Access Compliance Report

Public Rights-of-Way

(Curb Ramps)

Intersection ID: 46529	Main Street: BEAVER_CREEK_DR	Cross Street: PROSPERITY_CHURCH_RD	Location: SE
ADA ID: 3F72419FE1C7	Ramp Type: Perp	Initial Pass/Fail: Fail	Overall Compliance: No
Severity Score: 8.75			
Codes/Mitigation Info/Possible Solution		Field Measurements/Component Compliance

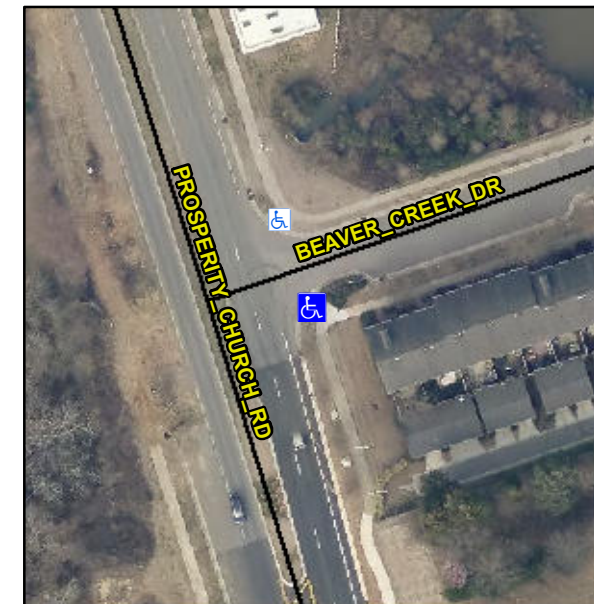
R304.5.1

Compliance	Description	Data	Compliance	Description	Data
N/A	Ramp Length (in)	97.0	Yes	Ramp Slope (%)	5.5
No	Ramp Width (in)	38.0	Yes	Ramp XSlope (%)	1.4
N/A	Flare Type LT	N/A	N/A	Flare Type RT	N/A
N/A	Flare Slope LT (%)	N/A	N/A	Flare Slope RT (%)	N/A
N/A	Flare Traversable LT?	N/A	N/A	Flare Traversable RT?	N/A
N/A	Landing Length (in)	N/A	N/A	DWS Provided?	N/A
N/A	Landing Width (in)	N/A	N/A	DWS Contrast?	N/A
N/A	Landing Slope (%)	N/A	N/A	DWS Length (in)	N/A
N/A	Landing X Slope (%)	N/A	N/A	DWS Full Width?	N/A
N/A	Landing Curb? (Y/N)	N/A	N/A	DWS Offset (in)	N/A
N/A	Shared Landing?	N/A			
N/A	Gutter Ponding?	N/A	N/A	Gutter Slope (%)	N/A
N/A	Gutter Lip Ht (in)	N/A	N/A	Gutter X Slope (%)	N/A
N/A	Painted X Walk1?	No	N/A	Painted X Walk2?	N/A
	X Walk 1 Direction	To N		X Walk 2 Direction	N/A
N/A	X Walk 1 Width (in)	N/A	N/A	X Walk 2 Width (in)	N/A
	X Walk 1 Slope (%)	2.2		X Walk 2 Slope (%)	N/A
	X Walk 1 X Slope (%)	1.1		X Walk 2 X Slope (%)	N/A

Remove & Replace Entire Ramp.
